[Docket No. FAA-2023-0921; Project  
Identifier AD-2022-01430-T; Amendment  
39-22471; AD 2023-12-13]

#### Airworthiness Directives; The Boeing Company Airplanes

**ACTION:** Final rule.

Figure 1 to paragraph (g)(2)(i)—*Fundamental Effective Isotropic PSD at Outside Interface of Aircraft Antenna*

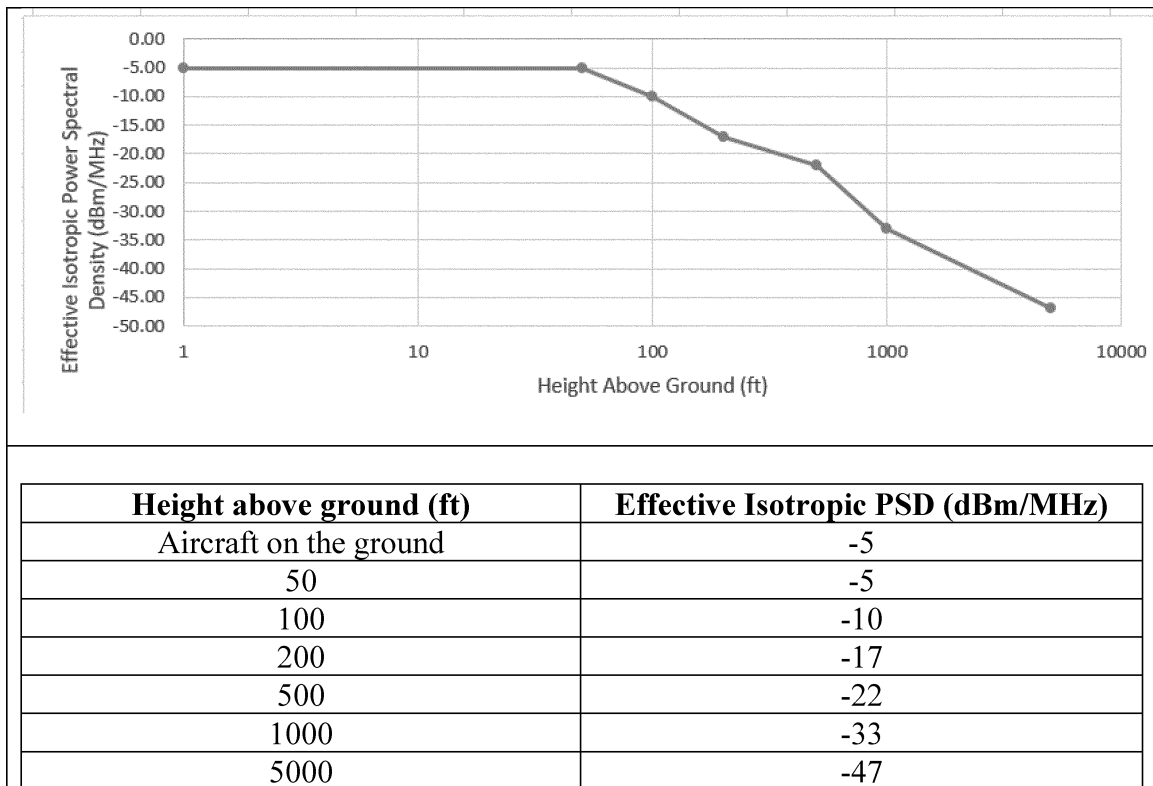
(i) Tolerance to radio altimeter interference, for the fundamental emissions (3.7–3.98 GHz), at or above the power spectral density (PSD) curve threshold specified in figure 1 to paragraph (g)(2)(i) of this AD.

Figure 2 to paragraph (g)(2)(ii)—*Spurious Effective Isotropic PSD at Outside Interface of Aircraft Antenna*

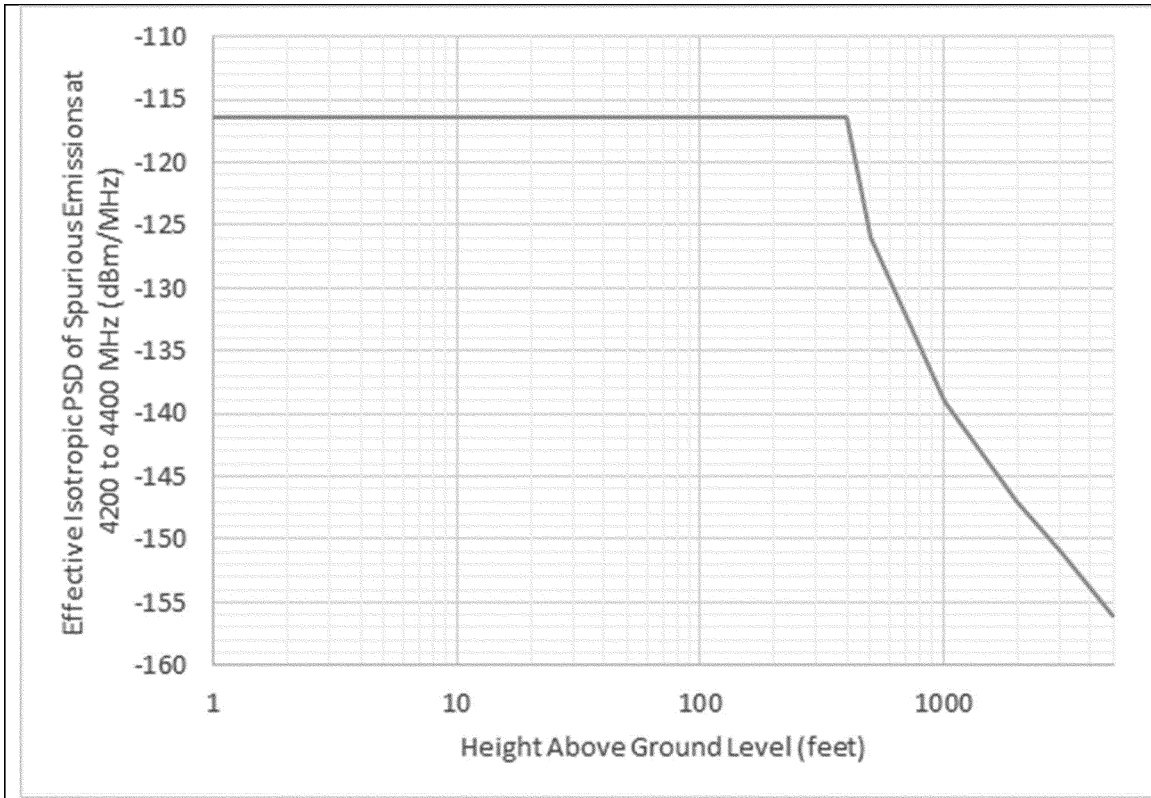
(ii) Tolerance to radio altimeter interference, for the spurious emissions (3.7–

3.98 GHz), at or above the PSD curve

threshold specified in figure 2 to paragraph (g)(2)(ii) of this AD.
